Product / Process Change Notification (PCN)	
<input checked="" type="checkbox"/> Major Change <input type="checkbox"/> Minor Change	
PCN Number: PCN_IndASI_20250108 Affected Series: WE-ASI Affected Order Codes: Please see table below in "Details of Change" PCN Date: 2024-10-08 (YYYY-MM-DD) Effective Date: 2025-01-08 (YYYY-MM-DD)	Change Category: <input type="checkbox"/> Equipment/Location <input type="checkbox"/> General Data <input type="checkbox"/> Material <input checked="" type="checkbox"/> Process <input checked="" type="checkbox"/> Product Design <input type="checkbox"/> Shipping/Packaging <input type="checkbox"/> Supplier <input type="checkbox"/> Software
Contact: Product Management Phone: +49 (0) 7942 - 945 5001 Fax: +49 (0) 7942 - 945 5179 E-Mail: pcn.eisos@we-online.com	Datasheet Change: <input type="checkbox"/> Yes <input checked="" type="checkbox"/> No Attachment: <input type="checkbox"/> Yes <input checked="" type="checkbox"/> No

Description of Change: In order to enhance the product reliability, Würth Elektronik eiSos will change the marking method from ink-marking to laser-marking. There will be no change in form, fit, function, quality or reliability of the product

Marking Change:

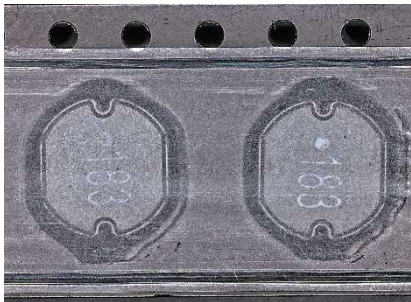
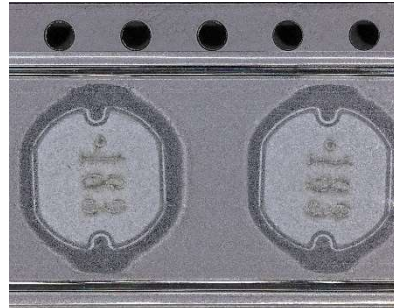
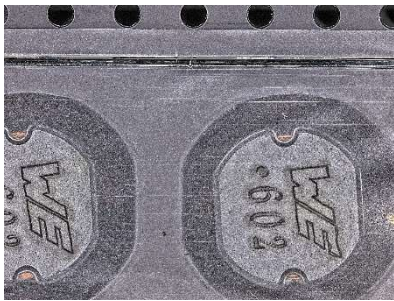
The marking method will change from ink-marking to laser-marking.
